# UNITED STATES PATENT AND TRADEMARK OFFICE

APPLICATION NO.	FILING DATE	FIRST NAMED INVENTOR	ATTORNEY DOCKET NO.	CONFIRMATION NO.
10/529,515	10/11/2005	Shi Su	B-5668PCT 622564-0	2407
36716	7590	10/04/2007		
LADAS & PARRY 5670 WILSHIRE BOULEVARD, SUITE 2100 LOS ANGELES, CA 90036-5679			EXAMINER KIM, TAE JUN	
			ART UNIT	PAPER NUMBER
			3746	
			MAIL DATE	DELIVERY MODE
			10/04/2007	PAPER

## Office Action Summary

## **DETAILED ACTION**

Figure 2

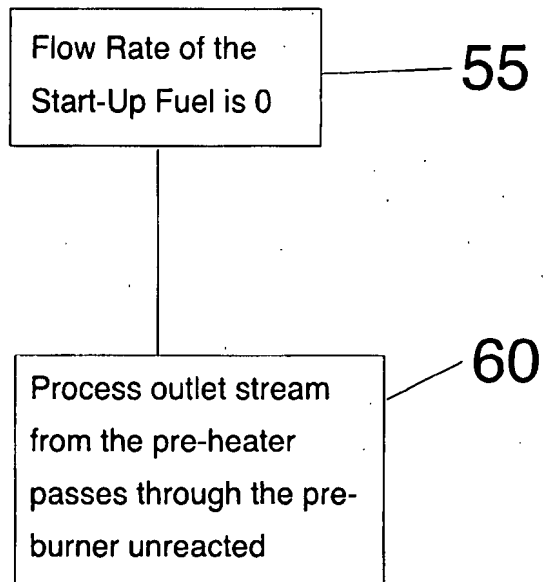
3. Entry of New Fig. 2 is approved.

Entry Approved
